Revised Estimate for Rs 21000/ for forming a layout of 37 Sites to the West of Navajyothi Studios at Saraswathipuram Mysore

OFFICE NOTE.

Sub:- Revised Estimate for Forming a layout of 37 sites to the west of Navajyothi Studios at Saraswathipuram, Mysore.

Subject: Revised estimate for Rs.21,000/- for forming a layout of 37 sites to the west of Navajyothi Studios at Saraswathipuram, Mysore.

CROSS SECTION.

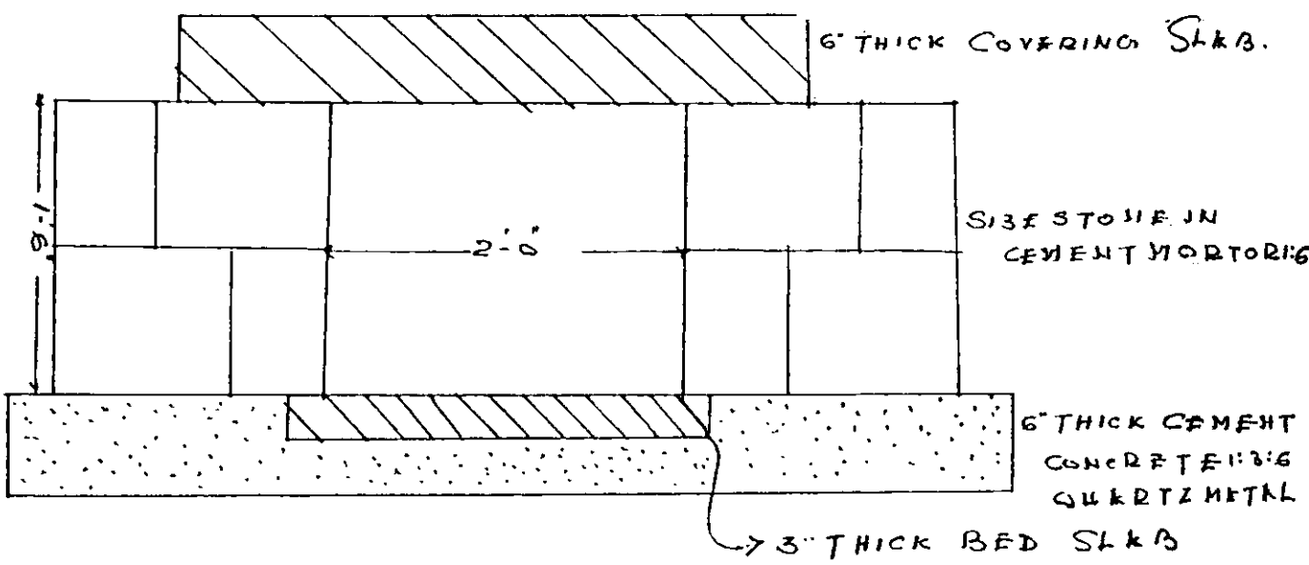
The quantities in respect of road crossings are checked only arithmetically as the relevant drawings are not made available.

The quantities in respect of road crossings are checked only arithmetically as the relevant drawings are not made available.

1. Section for the road crossing is herewith enclosed.
